## **Appendix D – Public Rights-of-Way Reports**

Healdsburg - Downtown Core - Curb Ramps

### Downtown Core - Curb Ramps

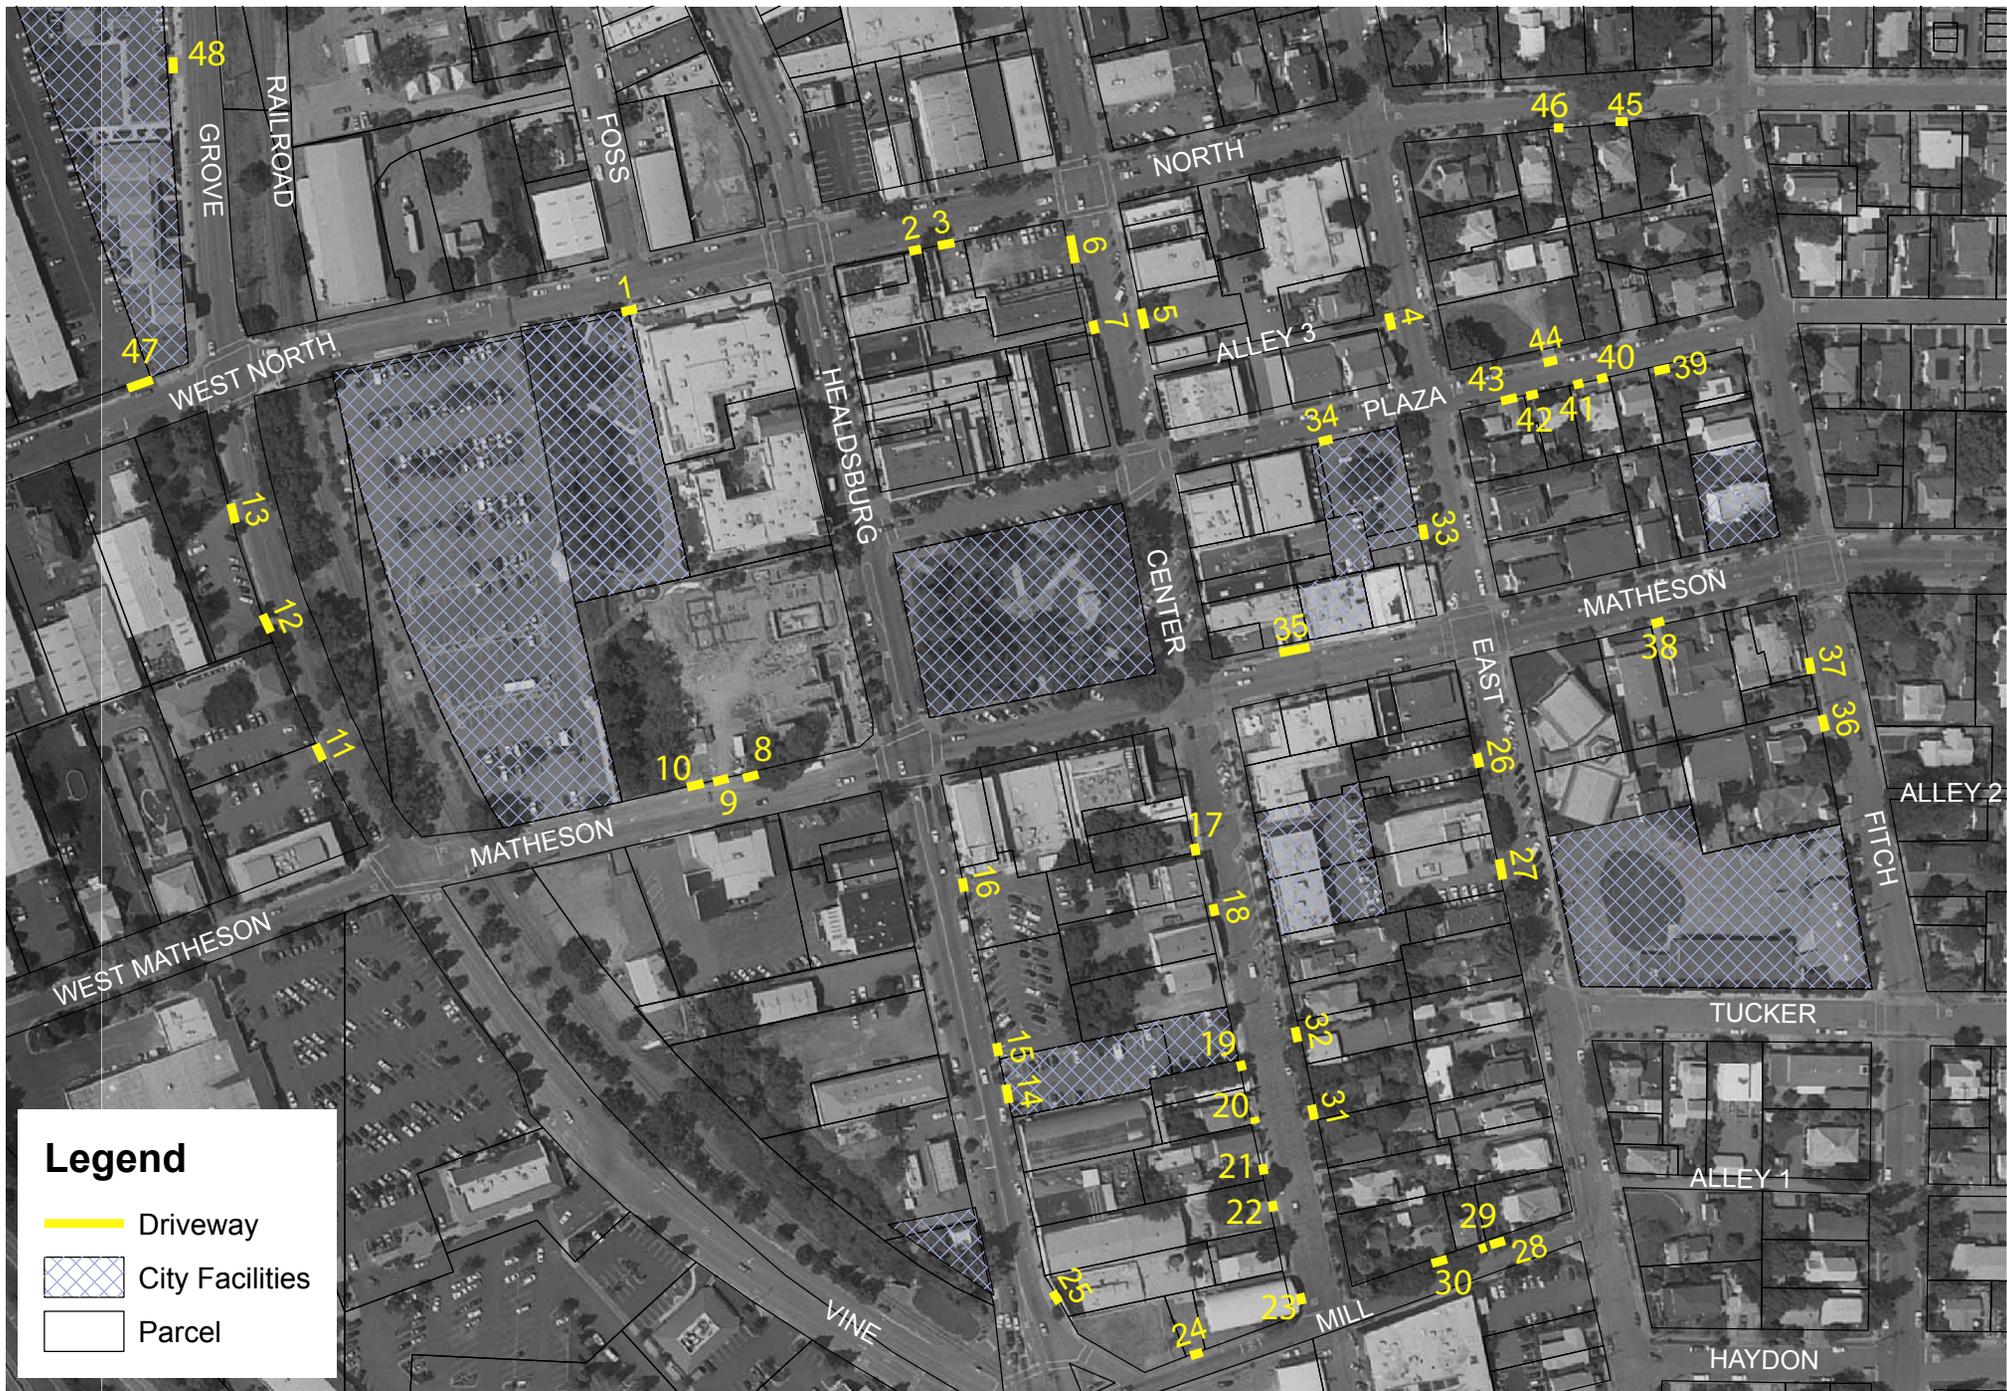
<b>Exterior</b>		
<b>3 - 100</b>	<b>Curb Ramp</b>	Priority:
<b>Install, replace or modify curb ramp</b>		\$2,500
Notes: Flared sides 11.2% - 9.5% (10.0% max.) Level landing slope 2.5% (2% max.) Gutter slope 7.5% (5% max.)		
State: 1127B.5 #3, 1127B.5 #4		
Federal: 4.7.5, 4.8.2		
<b>Provide detectable warning strip</b>		\$1,000
Notes: Detectable warning not provided.		
State: 1127B.5 #7		
Federal: 4.7.7		
<b>3 - 101</b>	<b>Curb Ramp</b>	Priority:
<b>Provide surface texturing</b>		\$300
Notes: Curb ramp surface material does not contrast with sidewalks.		
State: 1127B.5 #5		
Federal: -		
<b>Install, replace or modify curb ramp</b>		\$2,500
Notes: Flared sides 16.1% - 7.5% (10.0% max.) Gutter slope 10.0% (5% max.) Level landing slope 2.5% (2% max.)		
State: 1127B.5 #3, 1127B.5 #4		
Federal: 4.7.5, 4.8.2		
<b>3 - 102</b>	<b>Curb Ramp</b>	Priority:
<b>Provide surface texturing</b>		\$300
Notes: Grooved border not provided. Curb ramp surface material does not contrast with sidewalks.

State: 1127B.5 #5, 1127B.5 #6		
Federal: 4.7.4		
<b>Install, replace or modify curb ramp</b>		\$2,500
Notes: Level landing slope 4.2% (2% max.) Gutter slope 5.4% (5% max.)		
State: 1127B.5 #4		
Federal: 4.8.2		
<b>Repair surface</b>		\$250
Notes: Lip at gutter 1/2".		
State: 1133B.7.4		
Federal: 4.7.2		
<b>Provide detectable warning strip</b>		\$1,000
Notes: Detectable warning not provided.		
State: 1127B.5 #7		
Federal: 4.7.7
